UNITED STATES PATENT AND TRADEMARK OFFICE

APPLICATION NO.	FILING DATE	FIRST NAMED INVENTOR	ATTORNEY DOCKET NO.	CONFIRMATION NO.
09/935,869	08/23/2001	Jose Garcia Arumi	ARUMI	9449
7590 11/16/2004				
Ursula B. Day 350 Fifth Avenue, Suite 3220 New York, NY 10118				
			EXAMINER BAXTER, JESSICA R	
			ART UNIT 3731	PAPER NUMBER
DATE MAILED: 11/16/2004

Office Action Summary

DETAILED ACTION

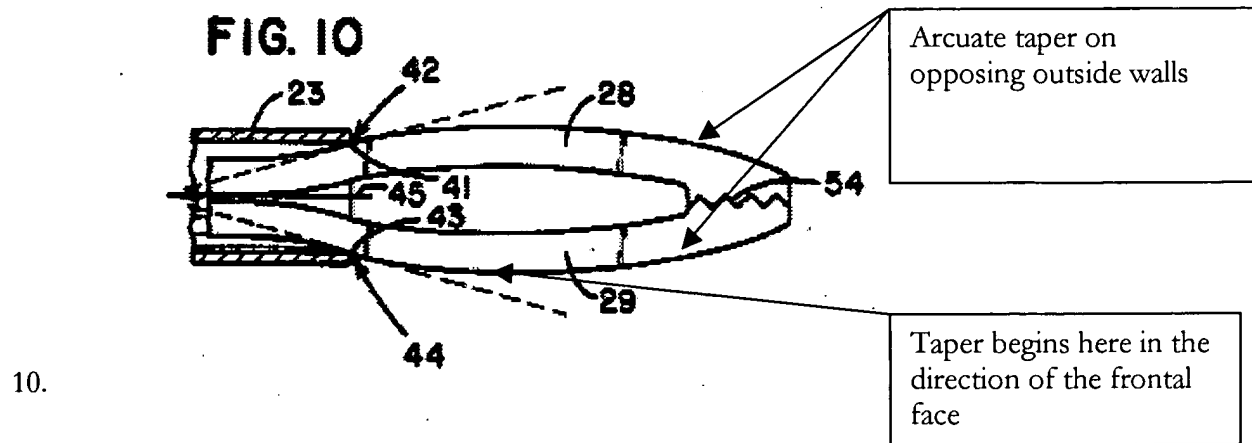
9. Applicant argues that the device disclosed by Sharpe et al. '973 does not disclose tapering arms as claimed by applicant. Applicant claims, "wherein the two arms starting from the cylindrical rod in the direction of the frontal face of the head piece when laterally viewed are tapered off with opposing outside walls of the taper configured in one of a straight or arcuate shape." The attached figure 10, clearly indicates how this claim limitation is met.

10.

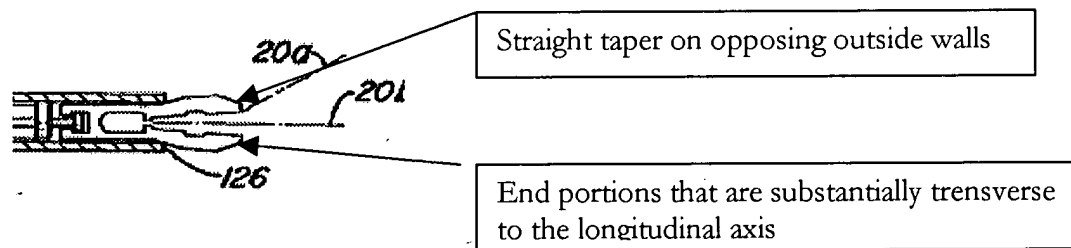
11. Applicant argues that Freitas et al. '185 does not disclose distal end portions that are substantially transverse to the longitudinal axis and the tapering of the arms as claimed by applicant. In Figure 4, Freitas shows the opposing outside walls with a straight taper and distal end portions that are substantially transverse to the longitudinal axis.
